**ADDENDUM NO. 1**

**February 10, 2015**

The original Contract Documents, for the Project entitled **CITY OF HIALEAH – PUBLIC WORKS COMPLEX-PARKING LOT-PAVING, DRAINAGE AND SITE LIGHTING-BID# 2014/15-3230-00-024** is hereby amended as noted in this **Addendum No. 1**.

DUMPSTER WALL SECTION

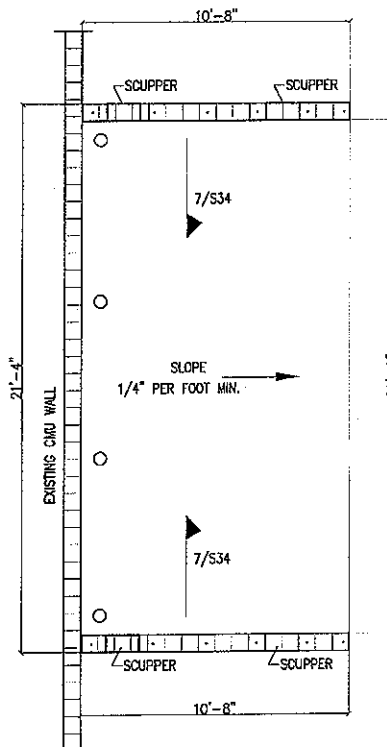
1. THE STRUCTURE FOR THE DUMPSTER ENCLOSURE AND TREATMENT COMPOUND SHALL BE INCLUDED AS PART OF THIS BID. CONTRACTOR IS ALSO TO INCLUDE THE STUCCO FINISH TO ALL EXTERIOR WALLS. THE GATES WILL BE PROVIDED AND INSTALLED BY THE CITY. PLEASE REFER TO DRAWINGS/SKETCHES FOR ADDITIONAL INFORMATION.

2. USE "DUMPSTER WALL SECTION" FOR THE TREATMENT COMPOUND WALLS. BOTH AREAS ARE TO HAVE A 6" SLAB WITH 6 X 6-W1.4 X W1.4 WWF.
3. THE CITY WILL COVER THE MASTER BUILDING PERMIT ONLY.
